**TOWN OF SWANSBORO
PLANNING BOARD
SPECIAL MEETING AGENDA**

Item To Be Considered: **Starbucks Special Use Permit**

TRC Comments
Starbucks
1117 W. Corbett Ave

Comment Response for Town of Swansboro, NC SUP

SHEET NUMBER
SP1
7 OF 14

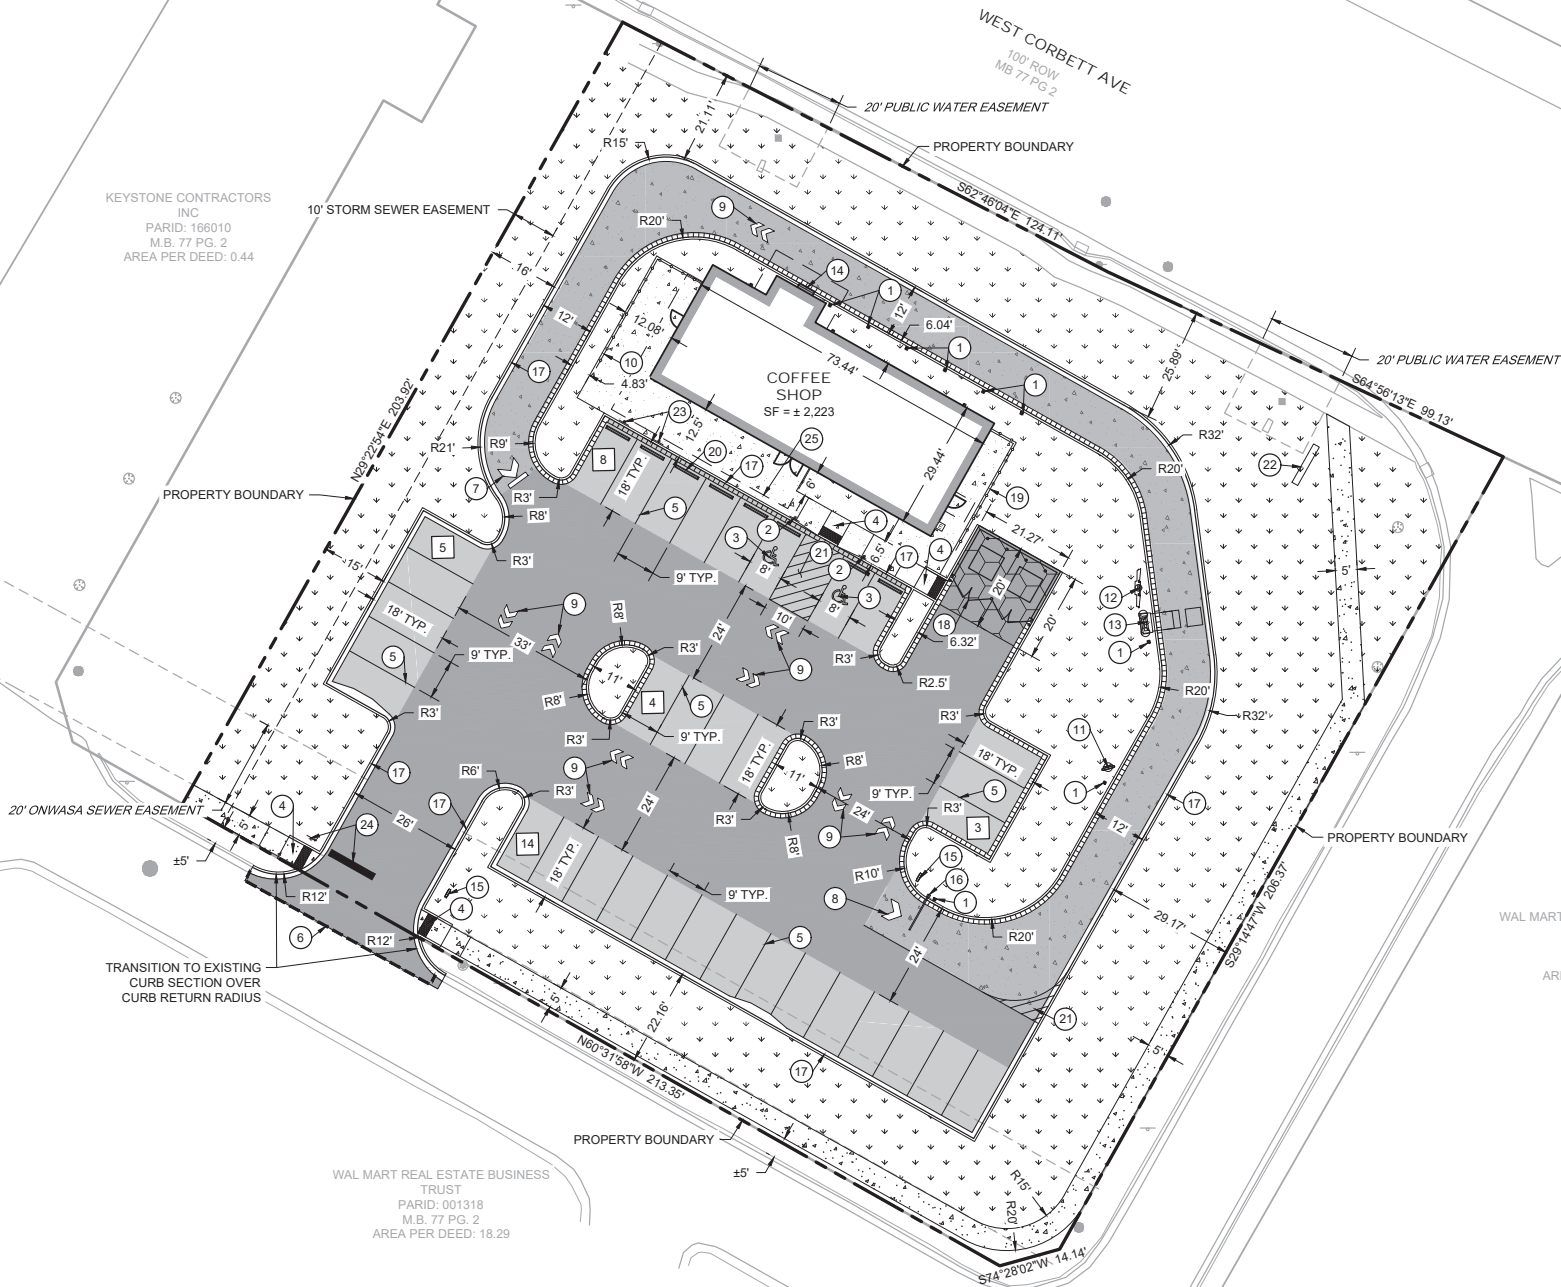
- ONWASA site plan approval is required following TRC approval.
- The ONWASA Utility Easement is incorrectly labeled as private, see attached map.

- [Section 152.295](#) requires parking lot interconnections between commercial developments.
 - [Section 152.528](#), (E), (1), requires that for every 50 linear feet, or fraction thereof, the five-foot-wide landscaped buffer yard shall contain one canopy tree with two under story trees or four under story trees, and six shrubs. [Section 152.529](#) requires that at least 8% of the gross paved area of the parking lot be landscaped, and [Section 152.539](#) requires an opaque enclosure with plantings for trash containment. These details and calculations need to be shown on the landscaping plan. See Section (F), (3) for placement.

- Sidewalks extending along the property boundary with the Walmart entrance and drive areas were discussed in our initial conversations with your office and should be shown.

Due to NC fire code and our FD having an aerial ladder, the entrance will have to be widened to 26 feet wide. Also, the center parking area will have to be redesigned some. A 26 foot wide access road must be available to drive the aerial into the parking lot. This could be done by removal of 1-2 parking spots in the center and sliding left parking island buffer moved into those spaces, therefore giving the 26-foot-wide required path.

- Per ONWASA: ONWASA site plan approval is required following TRC approval. The ONWASA Utility Easement is incorrectly labeled as private, see attached map. **Response: Private Easement has been relabeled to read ONWASA Easement.**

- Section 152.528, (E), (1), requires that for every 50 linear feet, or fraction thereof, the five-foot-wide landscaped buffer yard shall contain one canopy tree with two under story trees or four under story trees, and six shrubs. Section 152.529 requires that at least 8% of the gross paved area of the parking lot be landscaped, and Section 152.539 requires an opaque enclosure with plantings for trash containment. These details and calculations need to be shown on the landscaping plan. See Section (F), (3) for placement. **Response: We have provided landscaping around the enclosure.**

- Sidewalks extending along the property boundary with the Walmart entrance and drive areas were discussed in our initial conversations with your office and should be shown. **Response: Sidewalk has been added along the property boundary as requested.**

MEP SITE PLAN -
PHOTOMETRICS

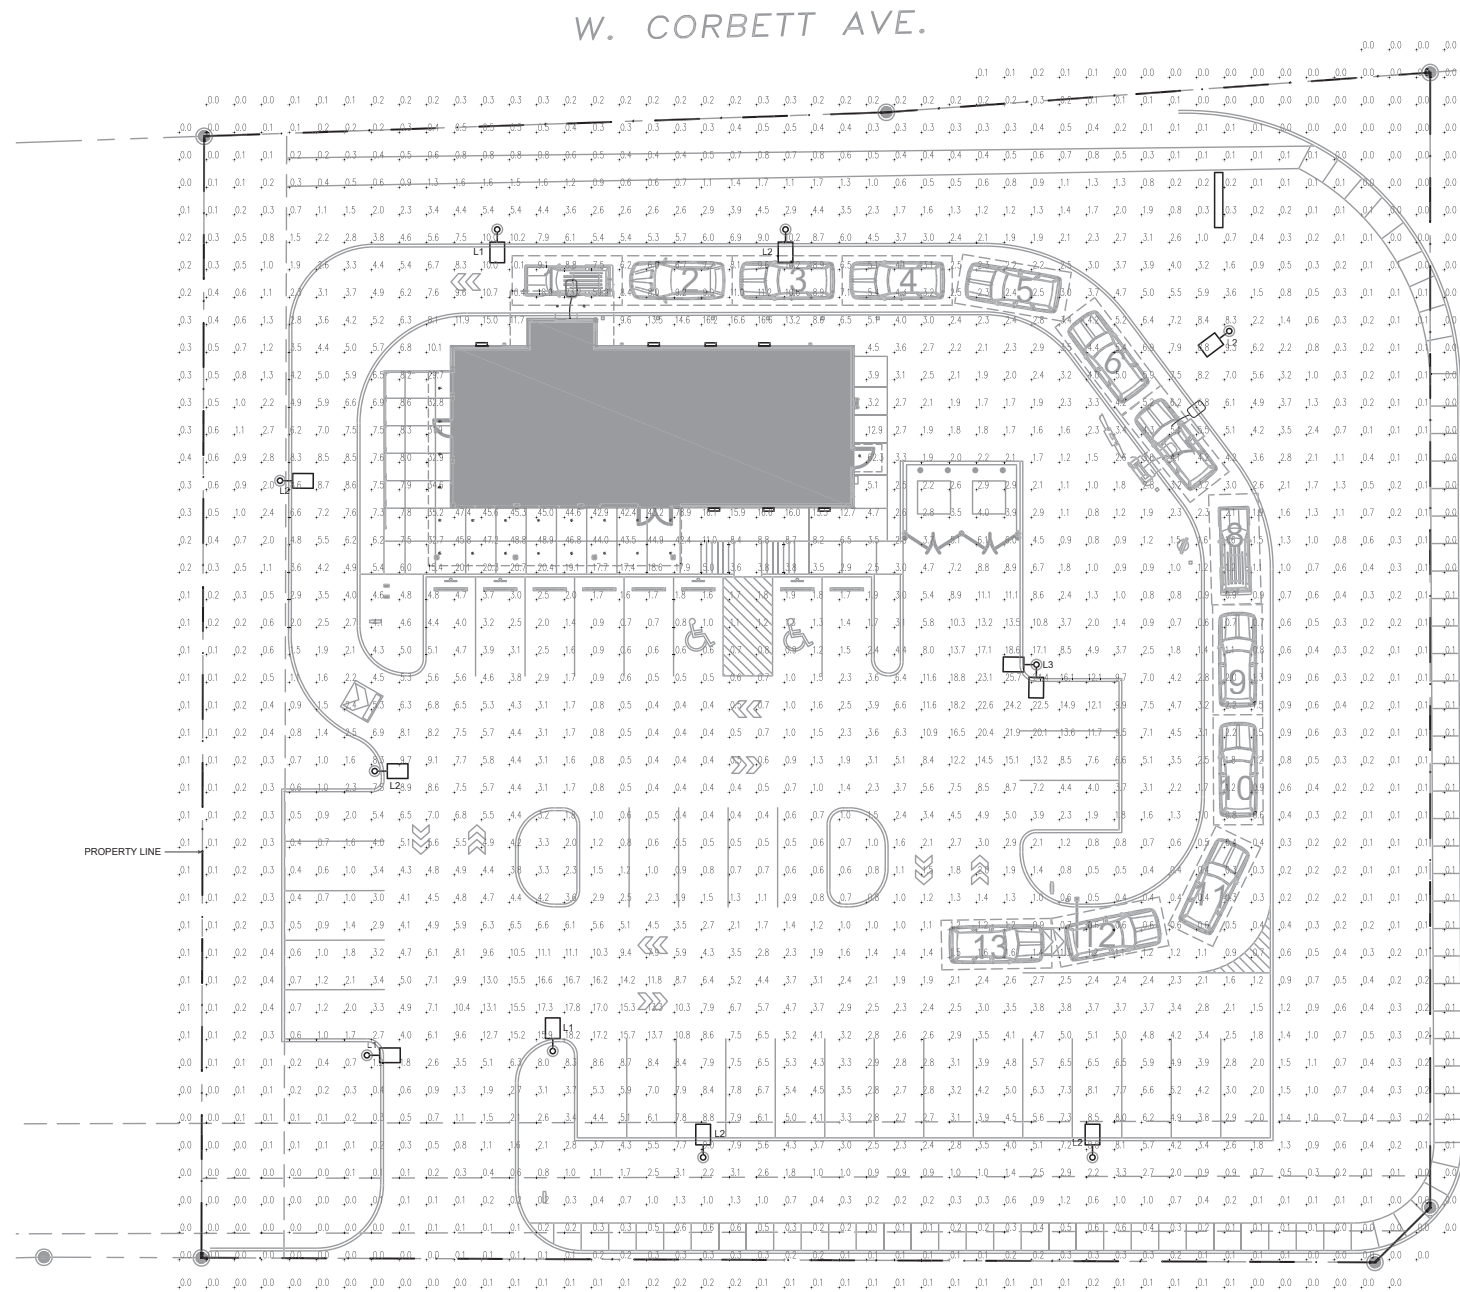
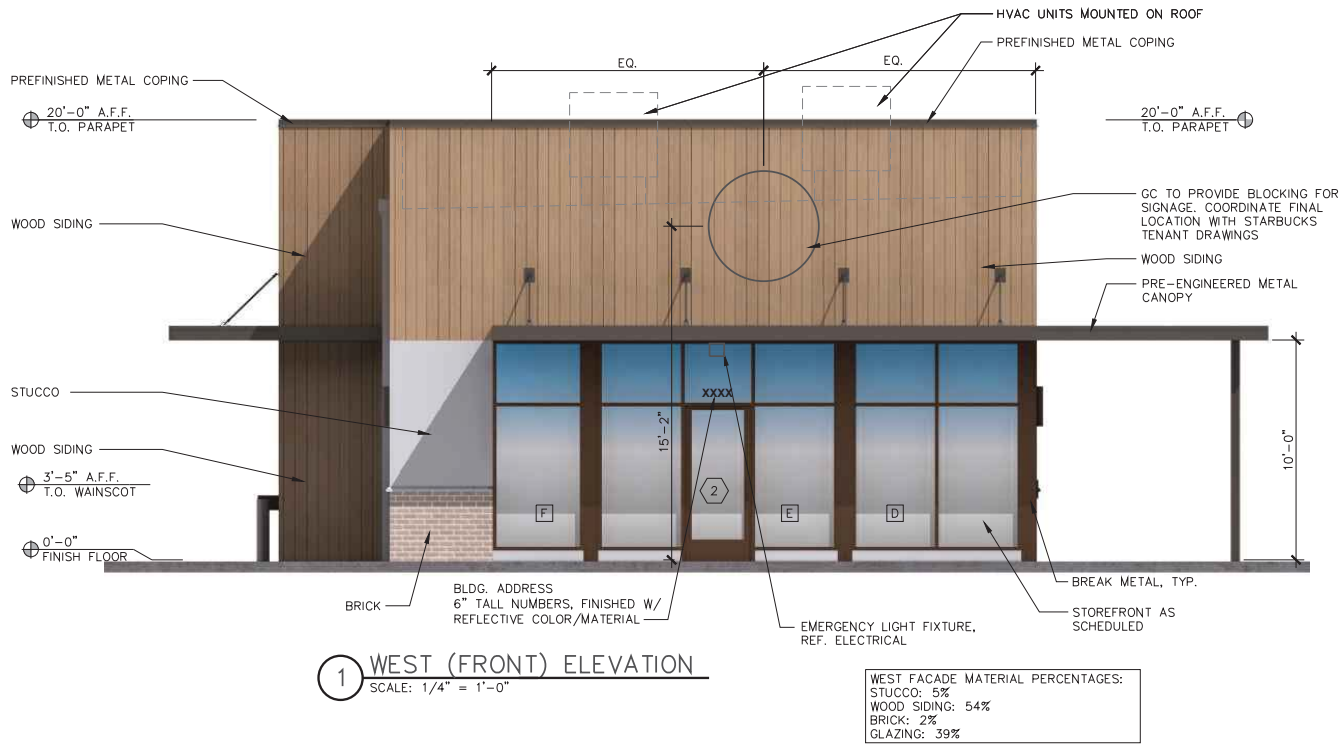
- A lighting plan should be submitted pursuant to [Section 152.501](#), or the fixture types/details added to the site plan. The plan submitted seems to conflict with [Section 152.503](#).

- A lighting plan should be submitted pursuant to Section 152.501, or the fixture types/details added to the site plan. The plan submitted seems to conflict with Section 152.503. **Response: We have adjusted our photometrics plan to show 0.5 footcandles or less at the property line.**

SHEET
A2.0
EXTERIOR
ELEVATIONS

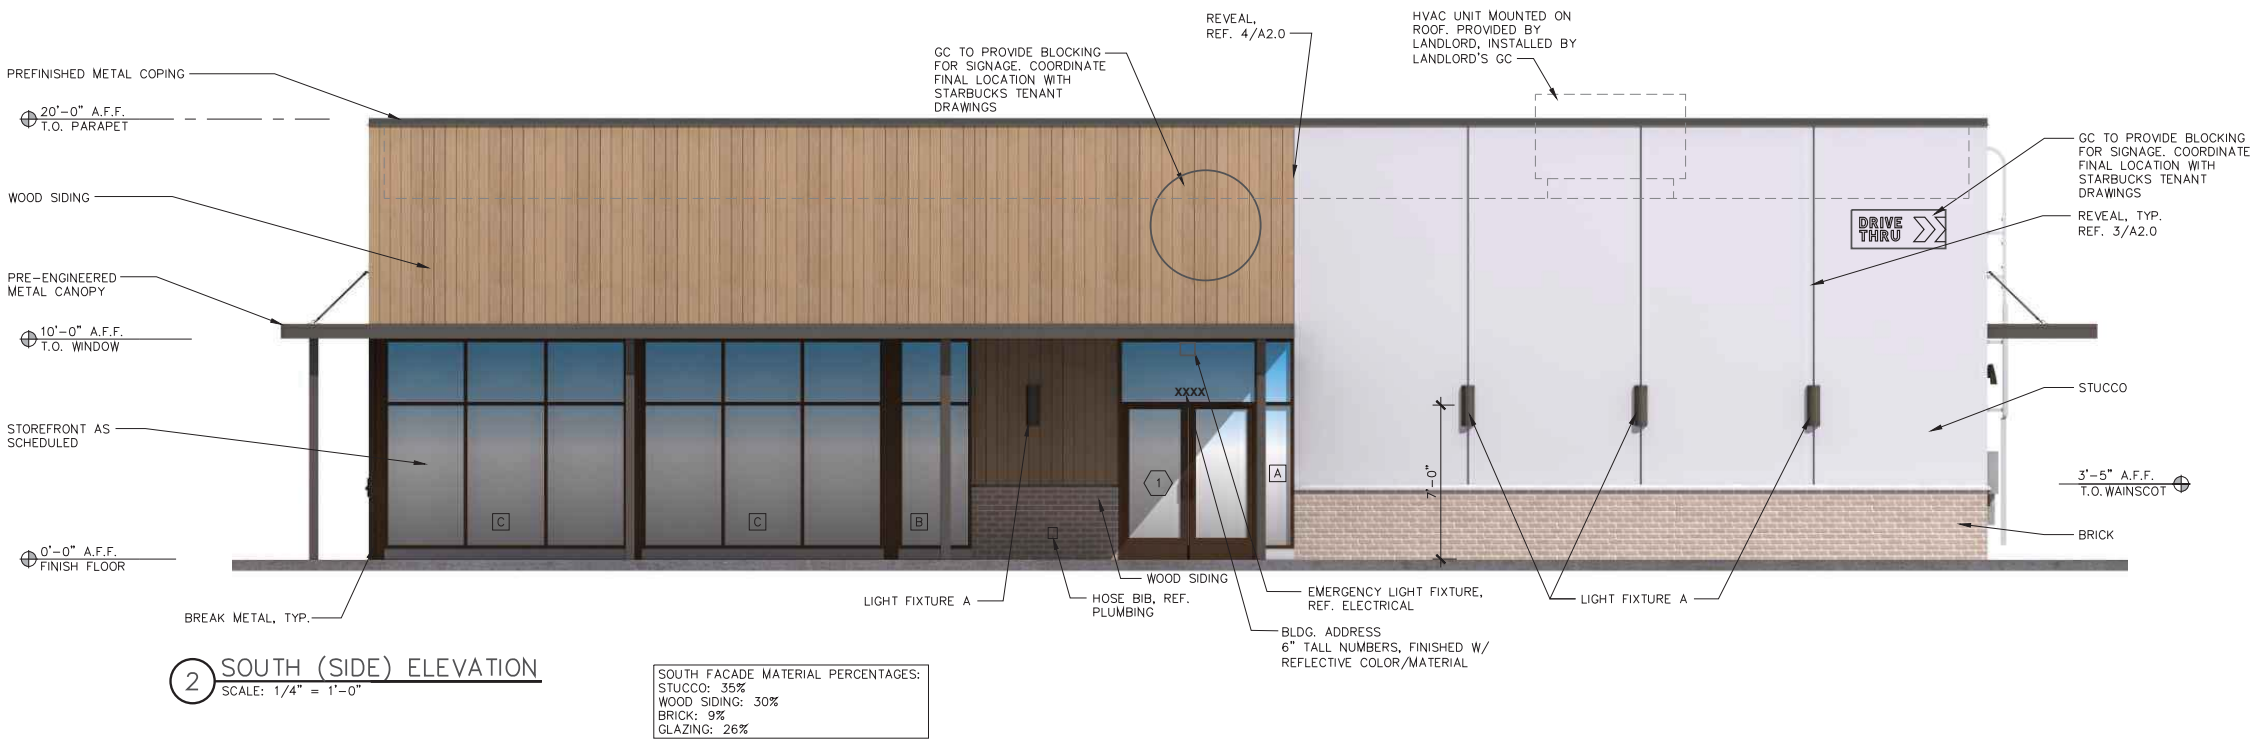
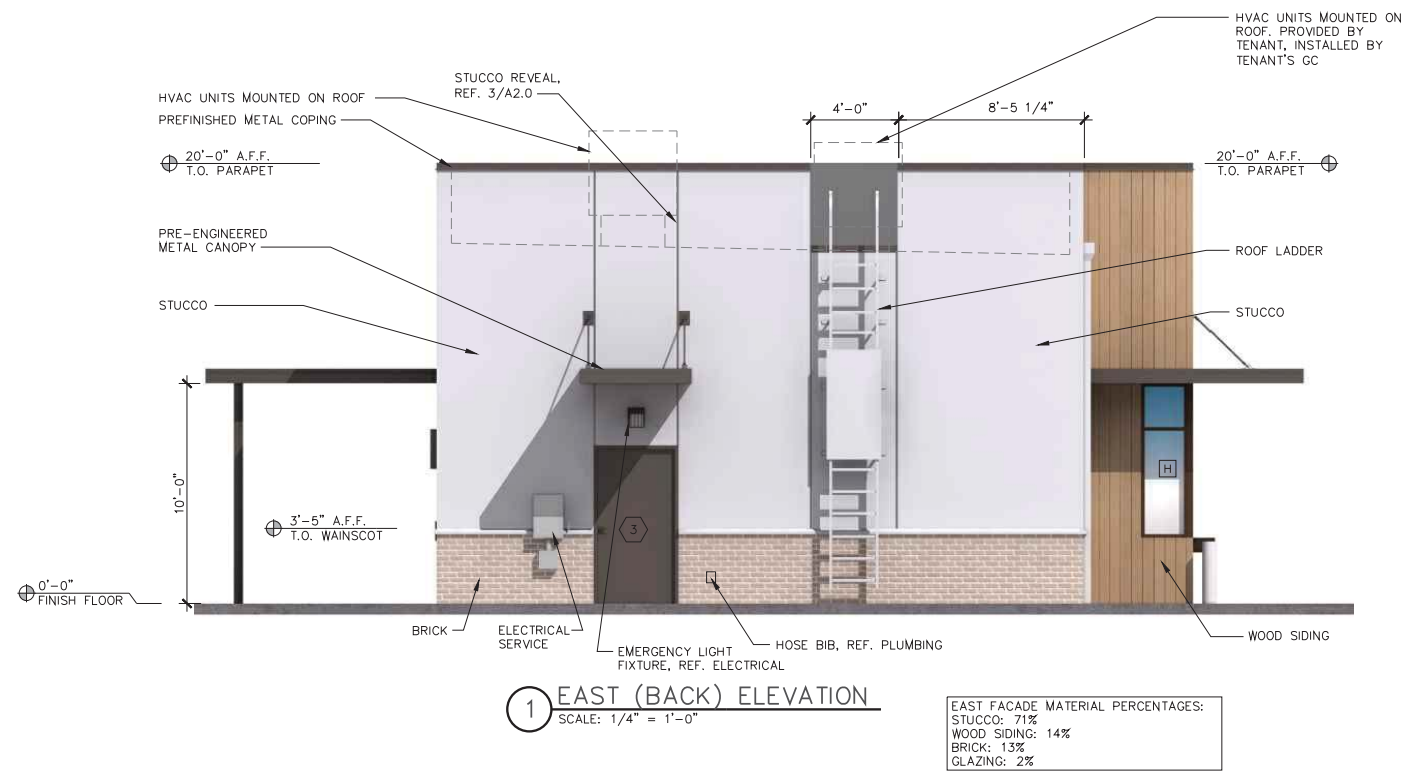
- At least one additional entryway feature is required on the front elevation and two on the south side elevation pursuant to this section.

- [Section 152.560](#) discusses architectural character and building materials. More detail is required for our review. (C) requires that at least 3 entryway features are provided.

- Section 152.560 discusses architectural character and building materials. More detail is required for our review. (C) requires that at least 3 entryway features are provided. **Response: We have added brick and added percentage of materials used for your review.**
